Access Compliance Report

Public Rights-of-Way (Curb Ramps)

Intersection ID: N/A	Main Street: HONEYMEADE_CR	Cross Street: PROVIDENCE_COUNTRY_CLUB_DR	Location: SW
ADA ID: 18AD4278442D	Ramp Type: Perp	Initial Pass/Fail: Fail	Overall Compliance: No
Severity Score: 1.25			
Codes/Mitigation Info/Possible Solution		Field Measurements/Component Compliance

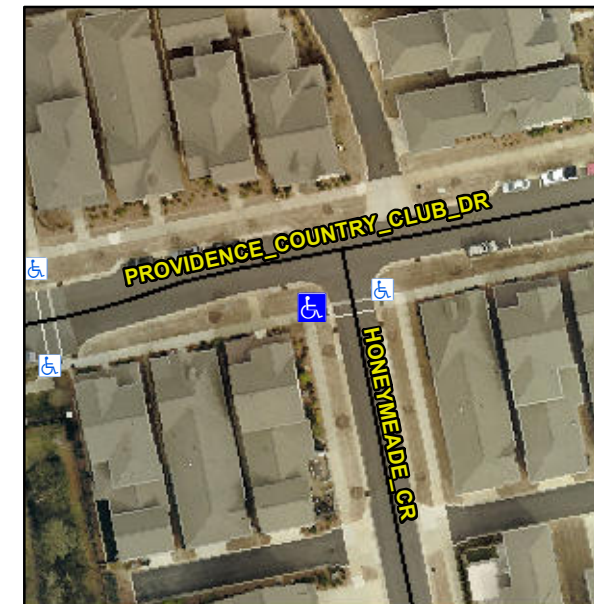
Not Found, R304.5.3

Compliance	Description	Data	Compliance	Description	Data
N/A	Ramp Length (in)	96.0	Yes	Ramp Slope (%)	5.4
Yes	Ramp Width (in)	71.0	No	Ramp XSlope (%)	2.7
N/A	Flare Type LT	N/A	N/A	Flare Type RT	N/A
N/A	Flare Slope LT (%)	N/A	N/A	Flare Slope RT (%)	N/A
N/A	Flare Traversable LT?	N/A	N/A	Flare Traversable RT?	N/A
N/A	Landing Length (in)	N/A	N/A	DWS Provided?	N/A
N/A	Landing Width (in)	N/A	N/A	DWS Contrast?	N/A
N/A	Landing Slope (%)	N/A	N/A	DWS Length (in)	N/A
N/A	Landing X Slope (%)	N/A	N/A	DWS Full Width?	N/A
N/A	Landing Curb? (Y/N)	N/A	N/A	DWS Offset (in)	N/A
N/A	Shared Landing?	N/A			
N/A	Gutter Ponding?	N/A	N/A	Gutter Slope (%)	N/A
N/A	Gutter Lip Ht (in)	N/A	N/A	Gutter X Slope (%)	N/A
N/A	Painted X Walk1?	No	N/A	Painted X Walk2?	N/A
	X Walk 1 Direction	To E		X Walk 2 Direction	N/A
N/A	X Walk 1 Width (in)	N/A	N/A	X Walk 2 Width (in)	N/A
	X Walk 1 Slope (%)	1.1		X Walk 2 Slope (%)	N/A
	X Walk 1 X Slope (%)	0.8		X Walk 2 X Slope (%)	N/A

Remove & Replace Entire Ramp.
